Access Compliance Report

Public Rights-of-Way

(Curb Ramps)

Intersection ID: 13604	Main Street: S_MINT_ST	Cross Street: WEST_BV	Location: N
ADA ID: C63BBF371784	Ramp Type: ParaDiag	Initial Pass/Fail: Fail	Overall Compliance: No
Codes/Mitigation Info/Possible Solution		Field Measurements/Component Compliance	
Severity Score: 22.5

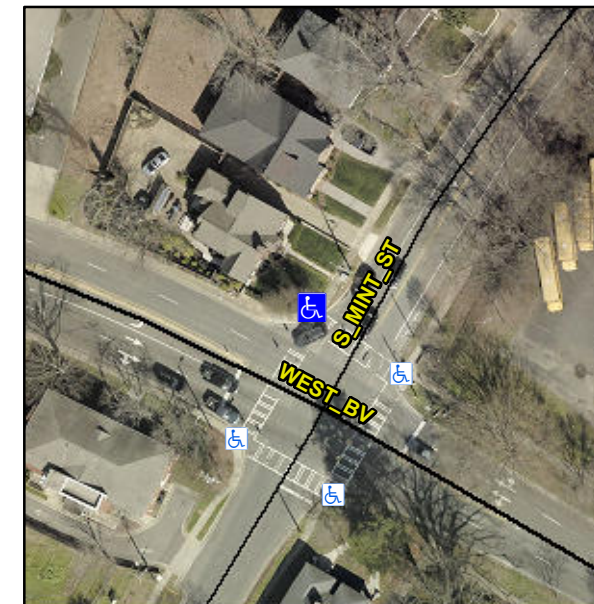
Surveyor Notes:

ASP LIP 1.0

PROW/ADA:

R304.5.1, R304.3.2, R304.5.3

Compliance	Description	Data	Compliance	Description	Data
N/A	Ramp Length LT (in)	63.0	N/A	Ramp Length RT (in)	51.0
No	Ramp Width LT (in)	44.0	Yes	Ramp Width RT (in)	60.0
No	Ramp Slope LT (%)	9.3	Yes	Ramp Slope RT (%)	5.8
Yes	Ramp XSlope LT (%)	1.4	No	Ramp XSlope RT (%)	3.4
N/A	Landing Length (in)	N/A	N/A	DWS Provided?	N/A
N/A	Landing Width (in)	N/A	N/A	DWS Contrast?	N/A
N/A	Landing Slope (%)	N/A	N/A	DWS Length (in)	N/A
N/A	Landing X Slope (%)	N/A	N/A	DWS Full Width?	N/A
N/A	Landing Curb? (Y/N)	N/A	N/A	DWS Offset (in)	N/A
N/A	Shared Landing?	N/A			
N/A	Gutter Ponding?	N/A	N/A	Gutter Slope (%)	N/A
N/A	Gutter Lip Ht (in)	N/A	N/A	Gutter X Slope (%)	N/A
N/A	Painted X Walk1?	Yes	N/A	Painted X Walk2?	Yes
	X Walk 1 Direction	To SW		X Walk 2 Direction	To SE
N/A	X Walk 1 Width (in)	92.0	N/A	X Walk 2 Width (in)	115.0
	X Walk 1 Slope (%)	4.4		X Walk 2 Slope (%)	1.0
	X Walk 1 X Slope (%)	1.6		X Walk 2 X Slope (%)	3.4
N/A	Ramp inside XWalk1?	Yes	N/A	Ramp inside XWalk2?	Yes

Road Slope (%)	1.6	N/A	Clear Space?	N/A
	Road X Slope (%)	3.6	N/A	Clear Space to XWalk (in)	N/A
N/A	Any Obstructions?	N/A	N/A	Storm Grate/Utility Hazard?	N/A
	Obstruction Type			Storm Grate/Utility Type	
		N/A			N/A
			Yes	Surface Condition? (G/P)	Good
			N/A	Curb Slope (%)	13.2

Possible Solutions:

Remove & Replace Curb Ramp With Two New Directional Ramps or Equivalent.
